# CITY OF ALBUQUERQUE

RE: **Lot 10 Block 9 Unit 22, S.A.D. 228**  
**6401 Petirrojo NW**  
**Grading and Drainage Plan**  
**Engineers Stamp Date Revised 5-17-17 (D10D003Q10)**  
**Pad Certification Dated 5/21/17**

Based upon the information provided in your submittal received 6/09/17, this plan is approved for Building Permit.

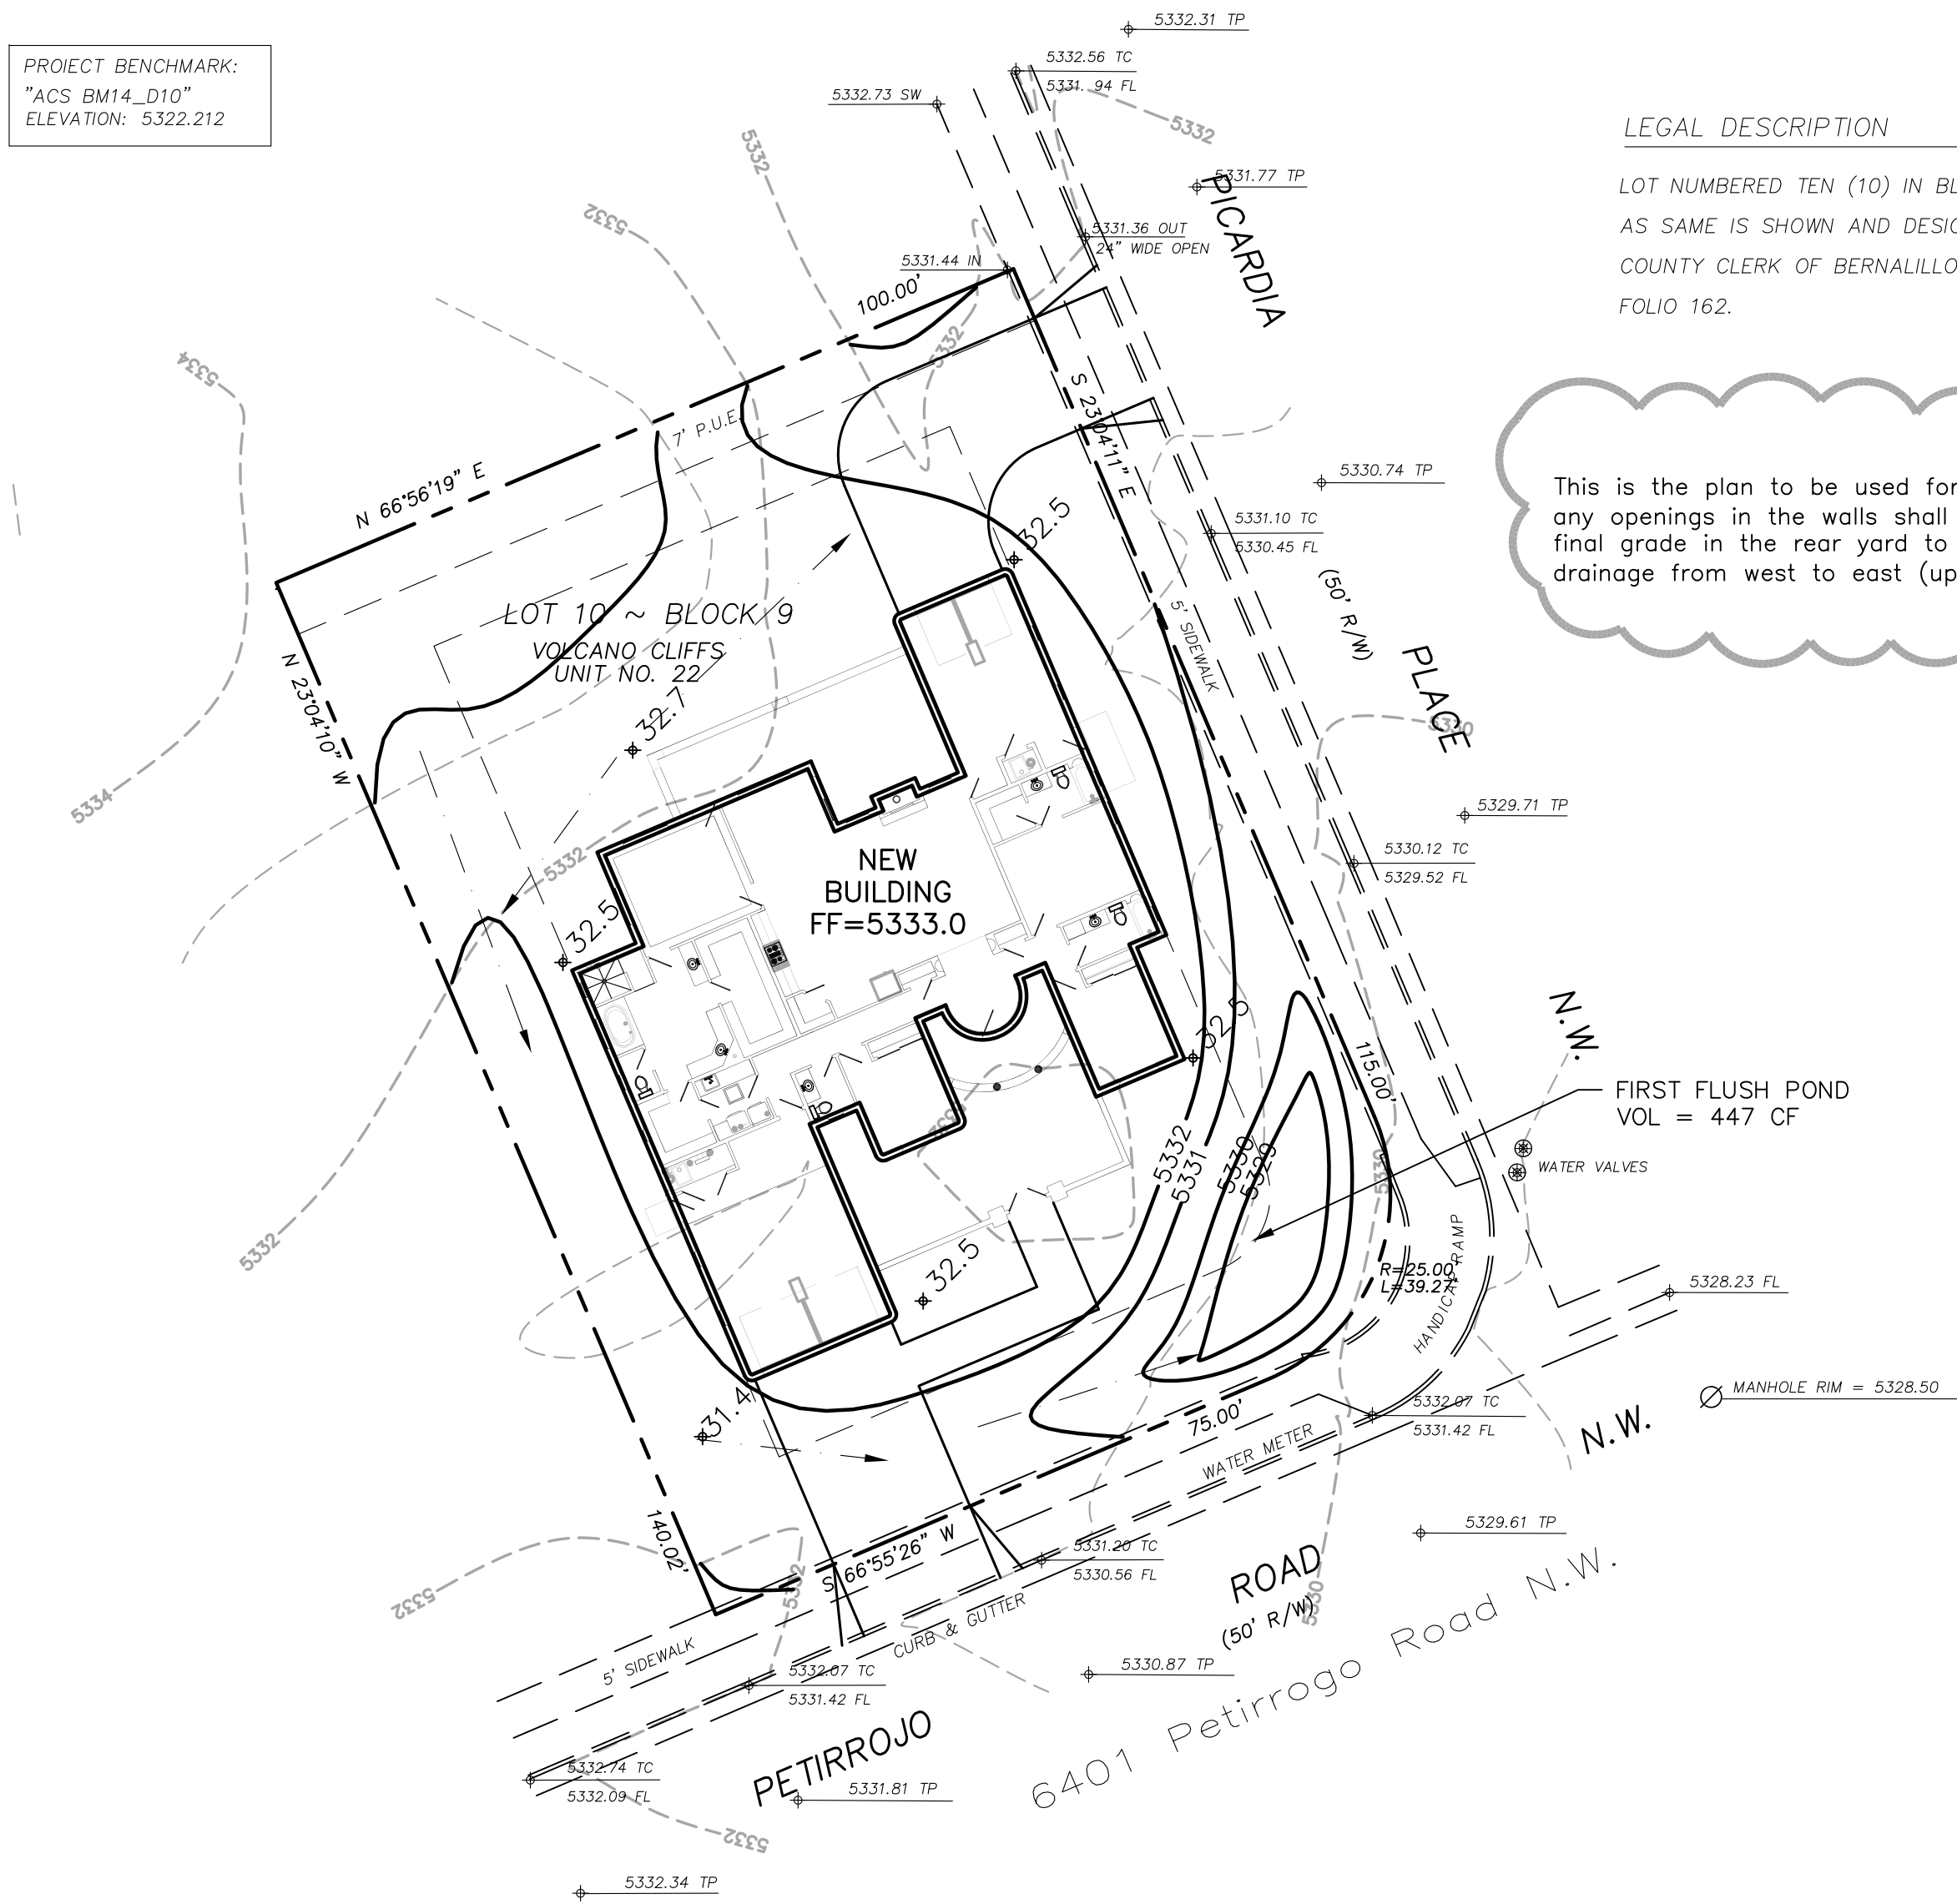
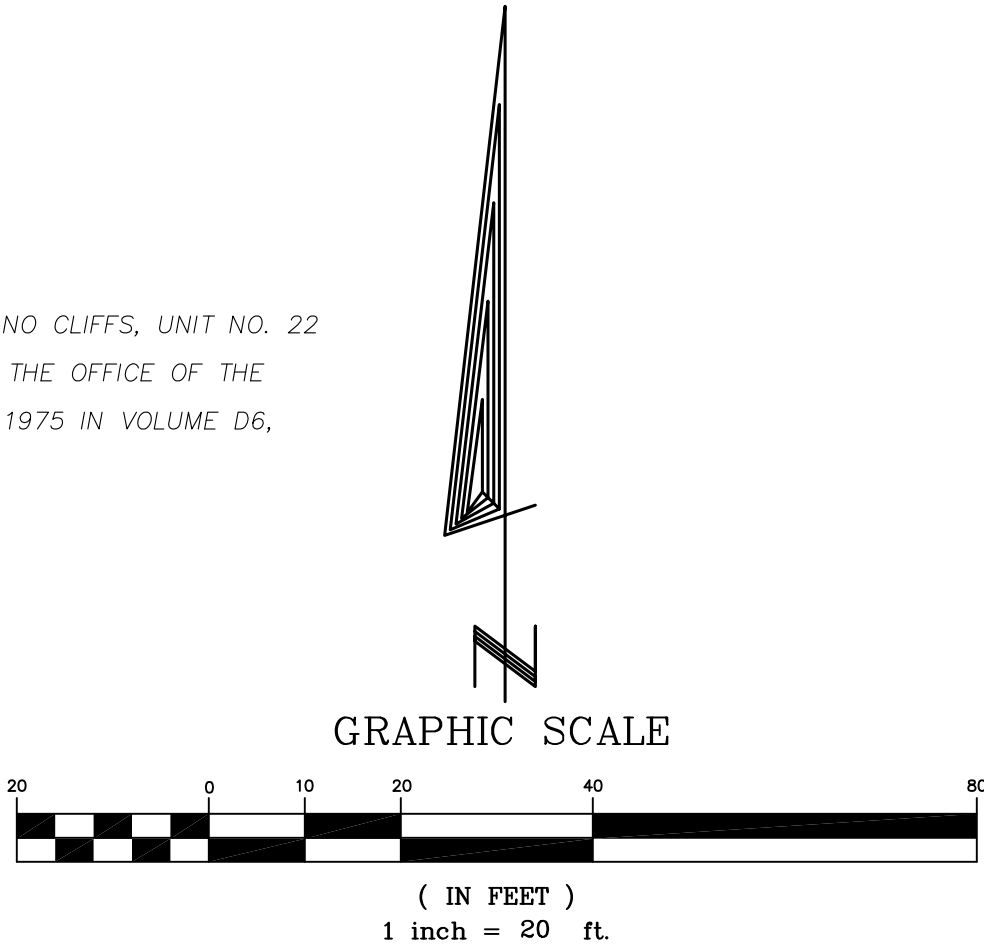
Please have the owner/builder attach a copy of this approved plan, to the construction sets in the permitting process prior to sign-off by Hydrology. Reiterate to the Owner/Contractor that a separate permit for a garden/retaining wall must be obtained, with the approved G&D plan revise date 5/17/17.

This is the plan to be used for any garden walls and any openings in the walls shall be placed 3" above final grade in the rear yard to allow for cross lot drainage from west to east (upstream to downstream).
